**FINAL DRAINAGE REPORT
FOR
RETREAT AT TIMBERRIDGE
FILING NO. 2**

Engineering Review

**EPC Planning & Community
Development Department**

PCD Project No. SF-21-021

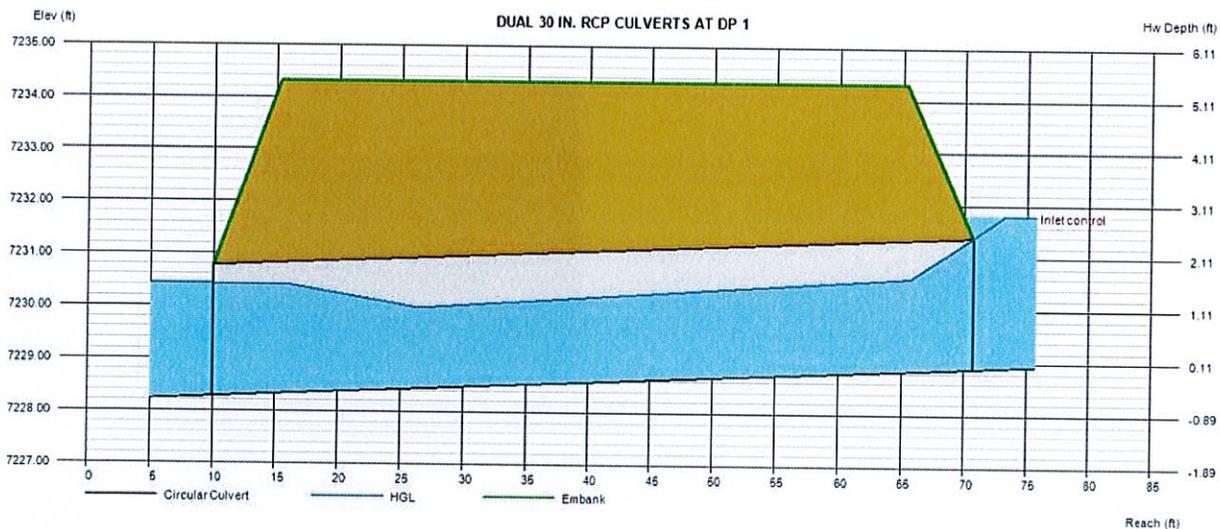
Include calculations for RR outlet protection, unless installed with Filing 1. If so, please note that in report and remove reference to rr calculations in report.

Project: Retreat at TimberRidge Filing No. 2
ID: DP-2 (24" Culvert)

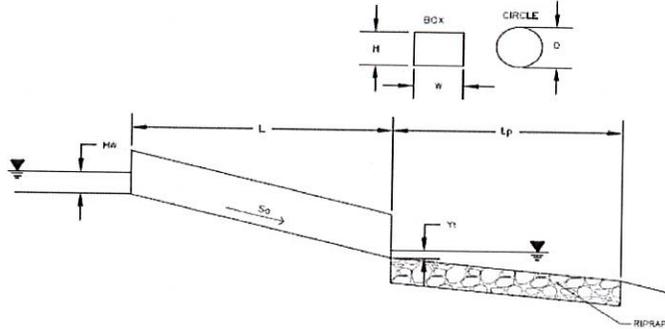
Update invert & pipe length to match culvert calculations on previous sheet
